June 13, 2022

Re: Preliminary Architectural Peer Review of Mill Creek Marshfield 40B

View of context within approximately half mile of site.

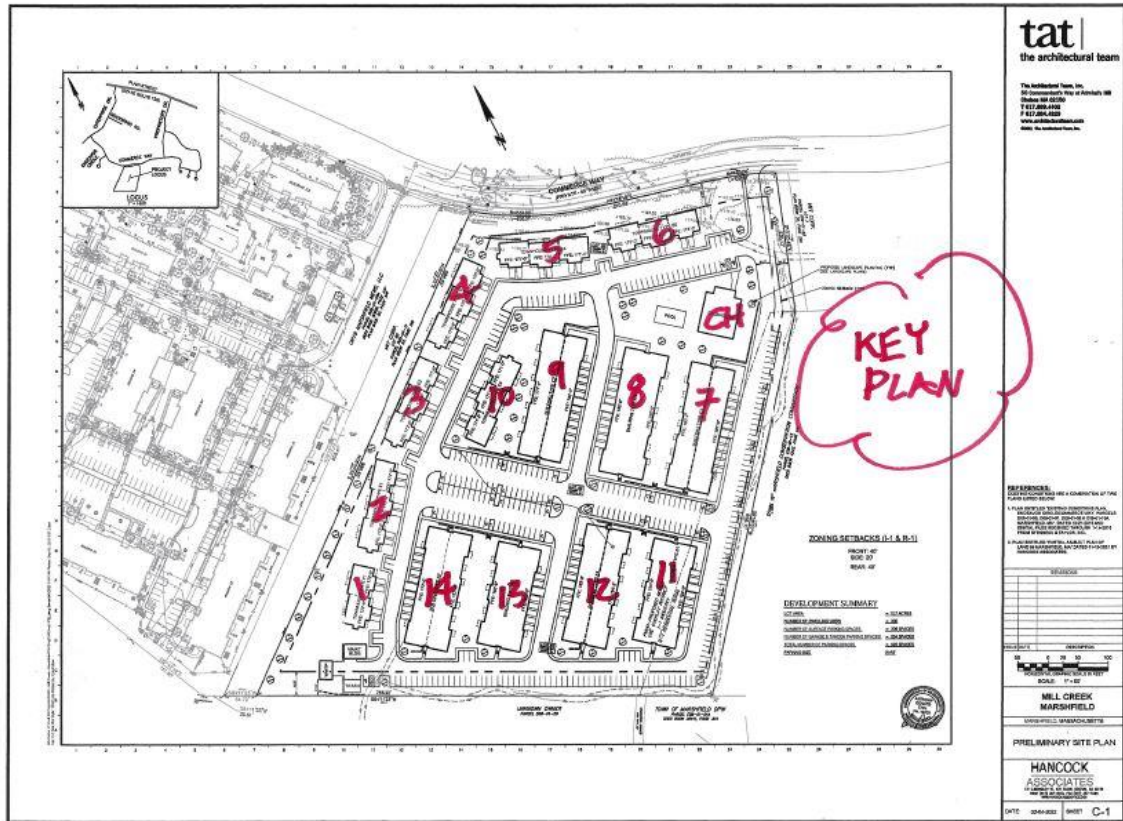
Brief Comments on site reconnaissance: The site is located on the south side of Commerce Way, about 1.7 miles east of the interchange with Route 3. To the west is a 240-unit project recently completed by the same developer, to the east is Sprague Forest and the Drake-Powell Memorial Forest, as well as other recently developed residential neighborhoods.

As is noted elsewhere in this letter, for a largely motor-dependent site, this one is relatively "amenity rich." Within an easily walkable range, facilitated by existing sidewalks, there is a supermarket, brewery, a few restaurants, and other commercial uses. Public facilities and open spaces include (or will include) the Rockwood Road Field Complex, a dog park, a Boy's and Girl's Club, and an Elementary and High School. There are also recently developed, very pleasant walkable residential areas nearby that include both singlefamily homes and multi-family developments.

There do not appear to be any dedicated bike lanes on any of the roadways within 1/2 mile of the site.
